# CONTRACT ADDENDUM NO. 1

## CITY OF PORT ORCHARD

### Marina Pump Station Improvements

#### Project No. PW2023-013

**CONCRETE REPAIR DETAIL**

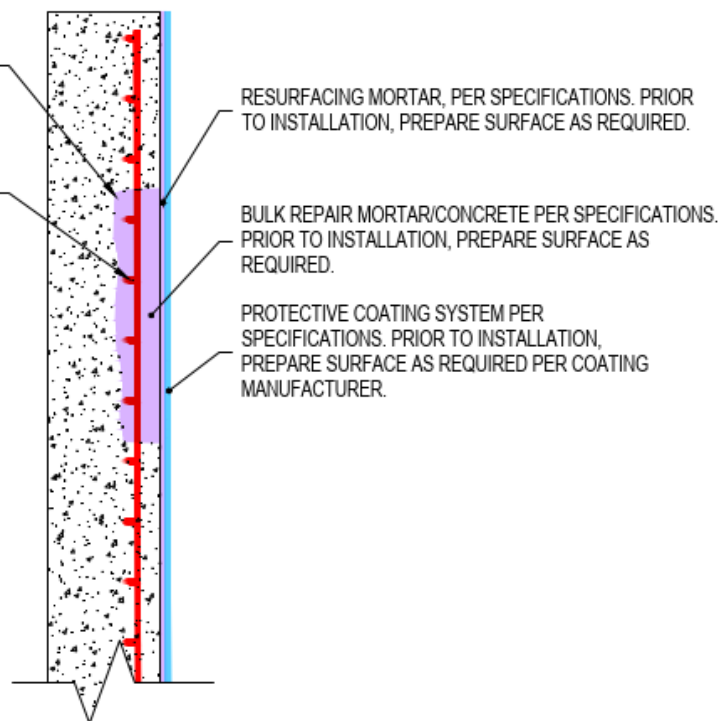
- a. **Detail 311 on DWG No. S704/ Sheet Number 77** – Revise the note calling out the spool as follows: “NEW SCH 316 SSTL SPOOL, **FLxFL WITH THRUST COLLAR**”. This sheet is not being reissued.
- b. **Add the detail for below for Concrete Repair to the contract plans:**

REMOVE DAMAGED CONCRETE. LENGTH AND WIDTH OF REMOVED AREA SHALL EXTEND 12" BEYOND OBSERVABLE CONCRETE/STEEL DETERIORATION. CHIP SIDES TO NEAR VERTICAL (DO NOT FEATHER EDGES). PROVIDE SURFACE PREPARATION AND TESTING AS REQUIRED FOR REPAIR MORTAR/CONCRETE.

PROVIDE CLEARANCE AROUND REBAR PER ICRI 310.1R, 1" MINIMUM. CLEAN AND PREPARE REBAR

NOTES:  
1. EXTENTS OF REMOVAL TO BE DETERMINED BY THE ENGINEER BASED ON FIELD OBSERVATIONS AND TEST RESULTS.  
2. SUBSTRATE ACCEPTANCE SHALL BE IN ACCORDANCE WITH MATERIAL MANUFACTURER'S WRITTEN SPECIFICATIONS.  
3. REPAIR MORTAR/CONCRETE, RESURFACING MORTAR, AND PROTECTIVE COATING/LINING MUST BE COMPATIBLE AND INSTALLED BY A MANUFACTURER-CERTIFIED APPLICATOR.
